MEDICAL DEVICE CORRECTION: EnRhythm® Pacemakers.

IMPORTANT: MEDICAL DEVICE CORRECTION

EnRhythm® Pacemakers

Example of interrogated battery voltage lower than ERI, but no ERI notification triggered

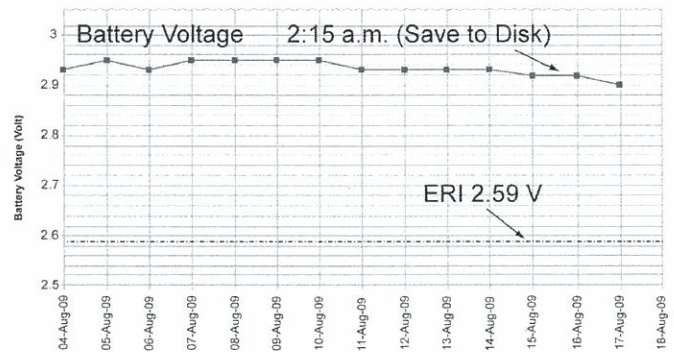
Medtronic has received 62 reports (out of approximately 110,000 devices worldwide) indicating that the battery voltage at device interrogation was lower than the battery voltage that is tracked by the device to provide data for the elective replacement indicator (ERI) notification. The lower voltage measurement has caused confusion and occasionally has resulted in unnecessary explants.

Medtronic's investigation has shown that none of these reports has resulted in loss of therapy. Importantly, the ERI notification, which uses the nightly battery measurement, is unaffected and accurate. Medtronic has identified the root cause as higher than expected battery resistance.

Data – Quick Look		Clinical Status Since Last Session	
Device Status		% of Time	
Battery Voltage	2.52 V	AS-VS	100%
ERI=2.59 V		AS-VP	0.0%
		AP-VS	< 0.1%
Interrogated Battery Voltage		AP-VP	0.0%
		MVP	On
		AT/AF	0.0%

Example of nightly voltage trend above ERI – stored to device memory but not visible to user

Medtronic's internal testing has shown that there is no current risk for compromised therapy delivery. If the software update referenced above is not implemented, there will be a potential risk of loss of device functionality in a small percent (less than 0.08% six years post implant) of devices. The software update will eliminate this risk.

Medtronic recommends physicians continue to use the ERI notification to determine time for device replacement. At this time, no other action, reprogramming or change in the frequency of follow-up is recommended.
